**NRC Staff Comments on: “Industrial Wastewater Closure Module for the Liquid Waste Tank 16 H-Area Tank Farm, Savannah River Site,” SRR-CWDA-2013-00091, Revision 0, February 2015,**

**Figure 3.1-12: Summary of Tank 16H Waste Removal During the CSR Campaigns**

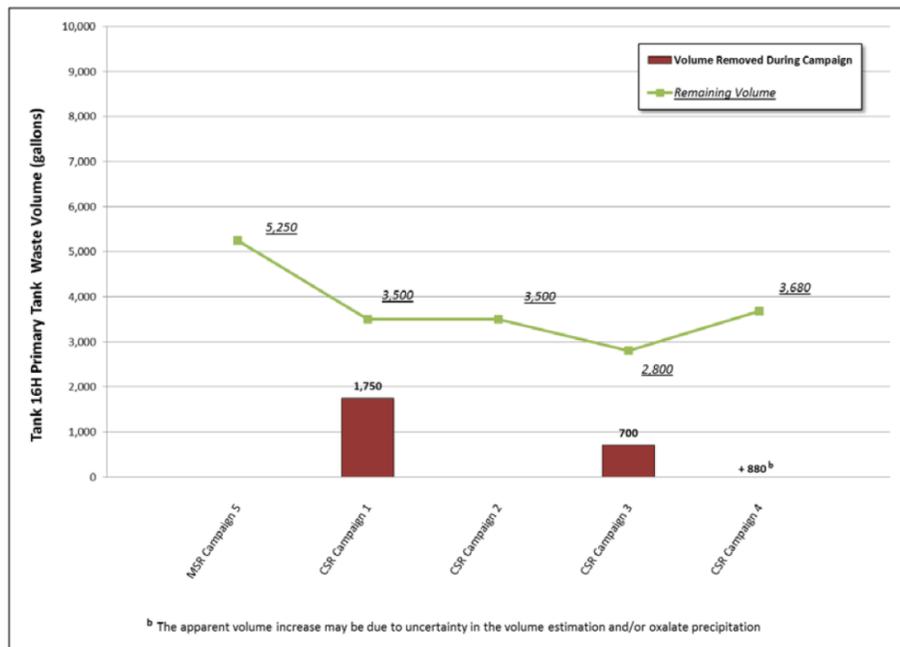
2.2 The Closure Module summarizes the cleaning campaigns to remove residual sludge from Tank 16H. The volume estimates provided suggest that the four chemical cleaning campaigns were marginally effective at removing waste from the tanks in comparison to the final rinse. From page 38:

Because of the uncertainty in volume estimates and the possible formation of oxalates leading to increases in volume, it is not clear that the volume estimates provided are a good indication of the effectiveness of oxalic acid (i.e., perhaps oxalic acid effectiveness is greater than the volume estimates suggest).

- *Does DOE have additional data to estimate the inventory before and after oxalic acid campaigns to provide a more informative evaluation of oxalic acid effectiveness (e.g., radionuclide concentration data before and after oxalic acid treatment)?*

Figure A12-1: Annulus Sample Locations and Image Locations

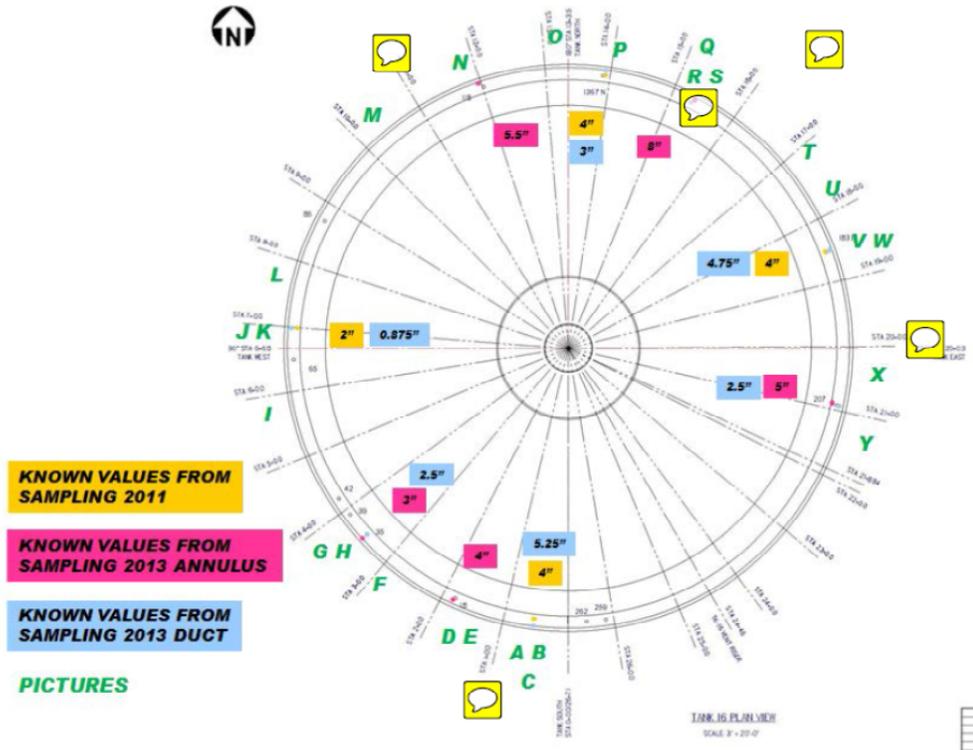
5.7 The Closure Module (page 18) states that “Due to leakage from the Tank 16H primary tank into the annulus pan, thirteen additional annulus riser openings, or inspection ports (IPs), were added later to permit 100% annulus inspections.” The southeast portion of the annulus was not accessed in 2013 (Figure A12-1 SRR-LWE-2012-00039) but visual observations were made in 2011 from the southeast portion of the tank near Stations 21+00, 23+00, 24+48, and 26+00 (Attachment 1 of SRR-LWE-2012-00039).

- *The Closure Module could better explain the limitations in visual observation of the annulus and how this impacted the areas that required interpolation versus the use of landmarks in photos. It is not clear if DOE verified its determination of measured or interpolated waste heights based on visual landmarks, or how DOE used visual tools to estimate waste heights where no measured sampling data was available. Could DOE explain why the inspection ports to the southeast of the annulus could not be used for visual observation in 2013 or what efforts were made to obtain access to this portion of the annulus to verify waste heights? Could DOE explain other limitations in visual observation of the annulus that would prevent 100% visual annulus inspections?*
